**APPLICATION FOR PERMISSION
UNDER SECTION 16 OF
THE TOWN PLANNING ORDINANCE
(CAP.131)**

Application for Permission under Section 16 of the Town Planning Ordinance (Cap. 131) for the Proposed Minor Relaxation of Building Height Restriction for Proposed Public Utility Installation (District Cooling System) in Area 56 of Hung Shui Kiu/Ha Tsuen New Development Area (Planning Application No. A/HSK/441)

Submission of Further Information

Response-to-Comments Table (**Appendix A**)

Drawing for Vehicular Access (**Appendix D**)

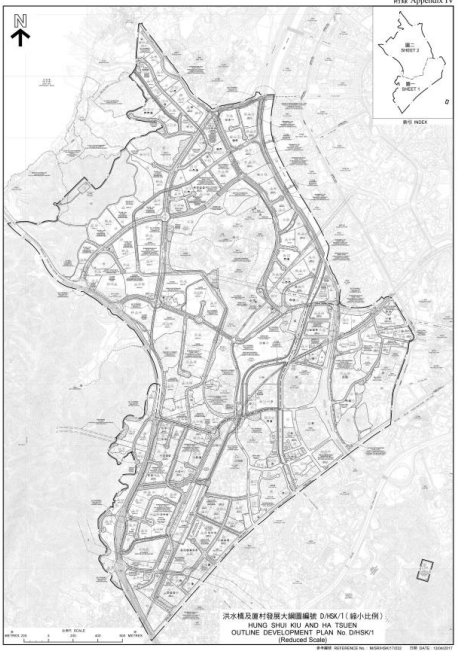
<p>2.</p>	<p>Transport Department, NT Regional Office, Traffic Engineering (NTW) Division, North West Section, dated 11 April 2023</p> <ul style="list-style-type: none"> Please clarify about the vehicular access route and the estimated trip generation/attraction rate of the proposed use. 	<p>For vehicular access route, please refer to the Appendix D – Drawing for Vehicular Access for details.</p> <p>For the estimated trip generation/attraction rate, it is estimated that on average 2-3 trips/hr is anticipated for normal operation, and thus we do not anticipate there are any significant impacts generated by the proposed use.</p>
------------------	--	---
